BRES1903-0046

John Rich
35 Carlisle Pl
Spring Lake, NC
28390

Architectural Control Request Information

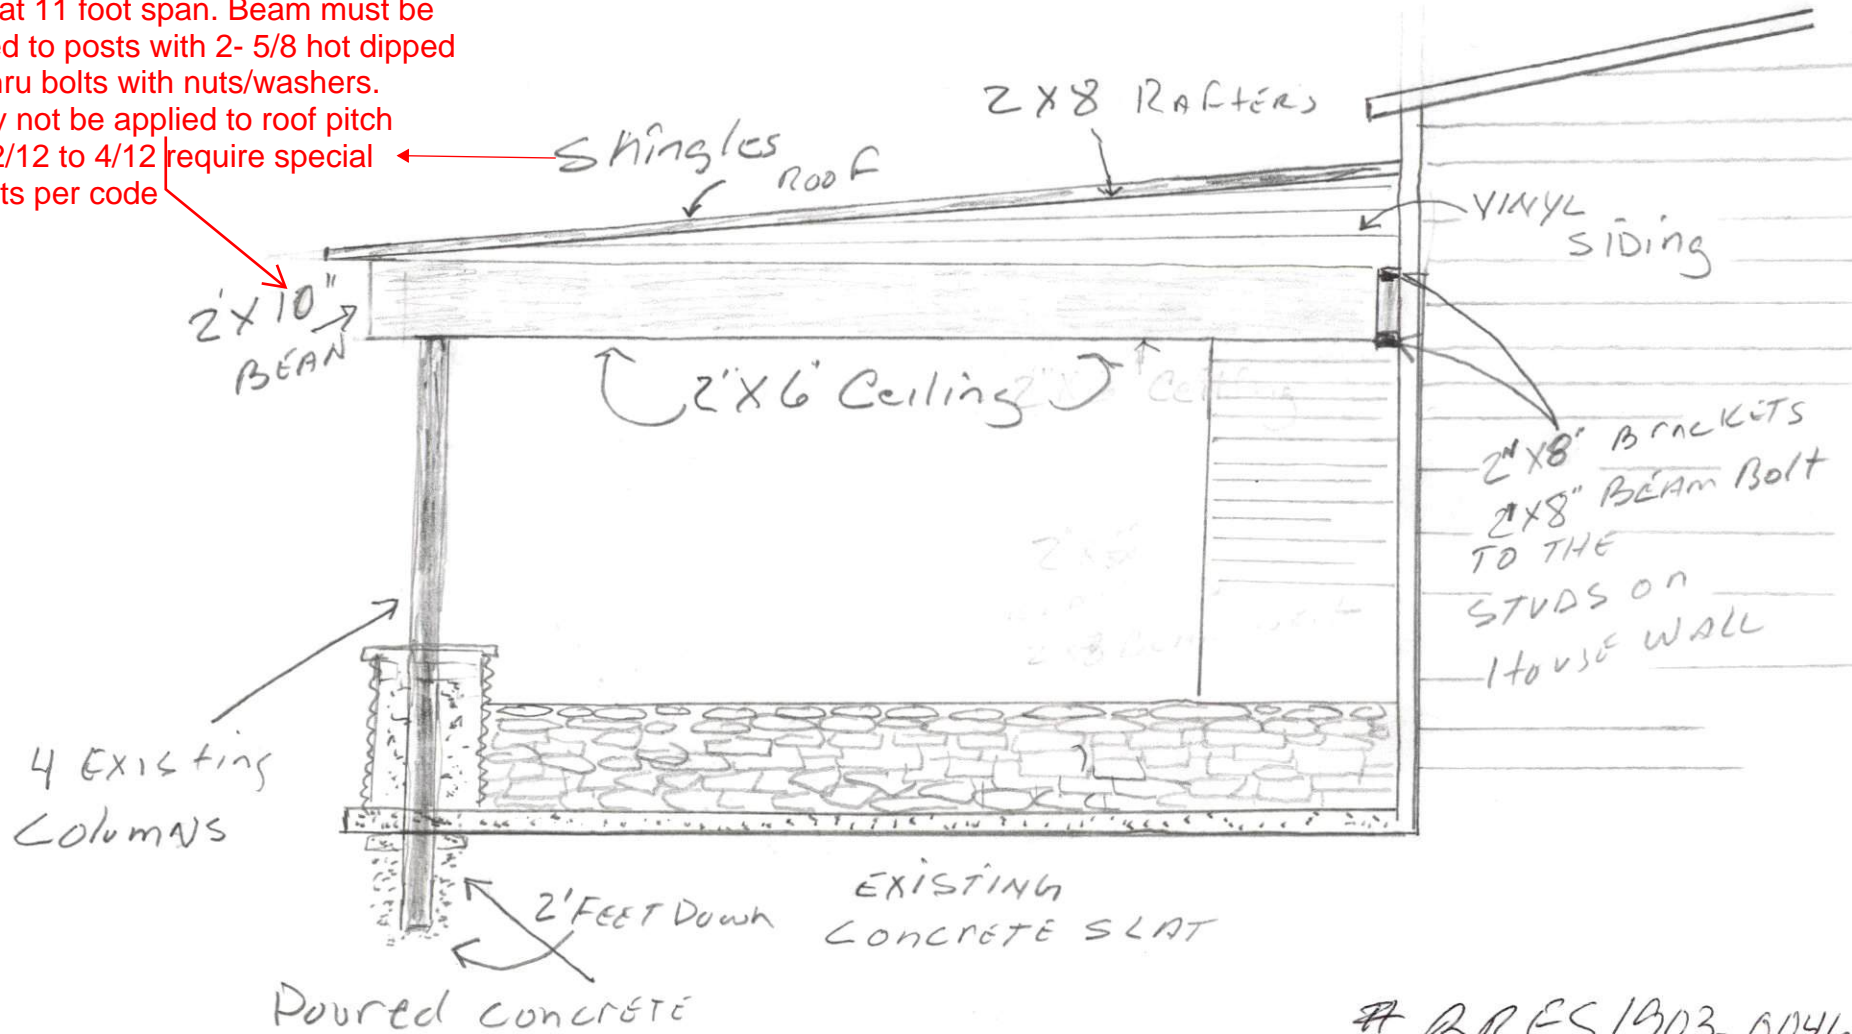
Beam must be minimum 3 ply 2x10 between center posts at 11 foot span. Beam must be through bolted to posts with 2- 5/8 hot dipped galvanized thru bolts with nuts/washers. Shingles may not be applied to roof pitch below 2/12. 2/12 to 4/12 require special underlayments per code
